**Proof of Evidence relating to the Statement of
Matters (211027) item 4; impact on Hobson's Park
and Nine Wells Local Nature Reserve.**

**IN RESPECT OF THE TRANSPORT AND WORKS ACT 1992: APPLICATION FOR
THE PROPOSED NETWORK RAIL (CAMBRIDGE SOUTH INFRASTRUCTURE
ENHANCEMENT) ORDER**

Planning Ref: 20/05054/CTY,
21/02957/TWA

Alistair Wilson (Streets and Open Space – Development Manager)

Map showing the Green Corridor Phases (extract from Appendix ii)

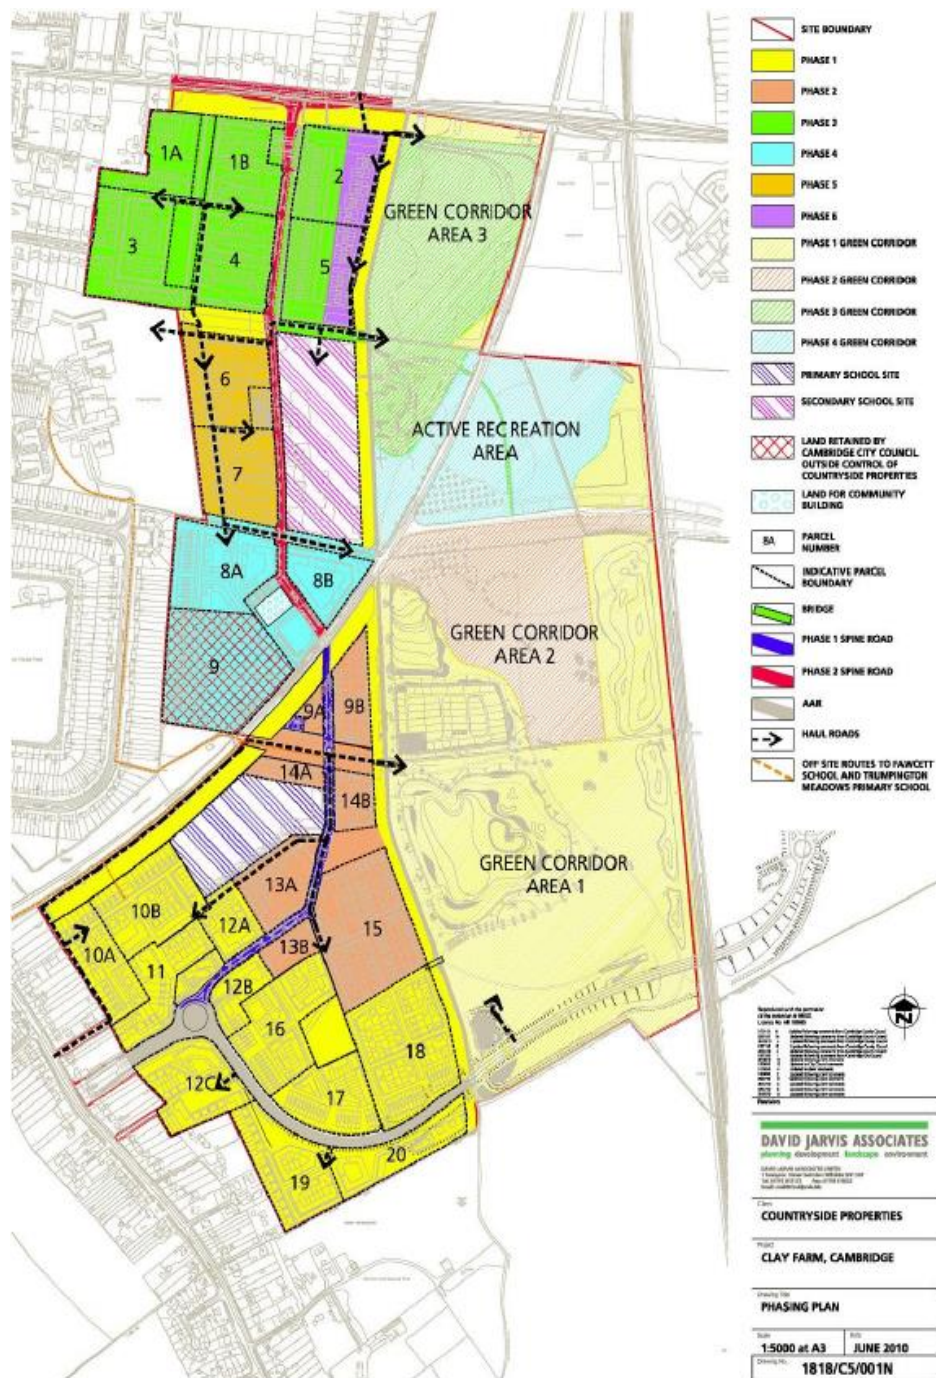
- 3.4 The phasing layout for the build of Hobson's Park is shown on a plan on page 5.
- 3.5 Hobson's Park provides sustainable urban drainage (SUD) in the form of three ponds (managed by Anglian Water).

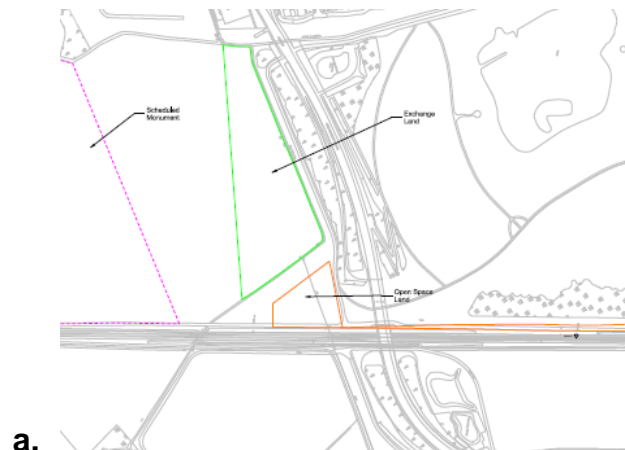
- i. The exchange land is bordered by Addenbrookes Access Road (AAA) to which the Clay Farm is predominately built to the North. The AAA is a very busy road and there are currently no controlled crossing points to allow access to the exchange land.
- ii. The exchange land is only accessible (without crossing AAA) from the Hobson's Park by access under the Addenbrookes Road bridge. This land also includes railway infrastructure in proximity. See the plan extract below.

- iii. At this point no landscape plans have been presented in respect of the lay out and purpose of the exchange land or how it will be accessed. The exchange land has limitations in respect of access due to a watercourse to two sides of its boundary and this has a significant impact on accessibility and its potential contribution as mitigation for the scheme
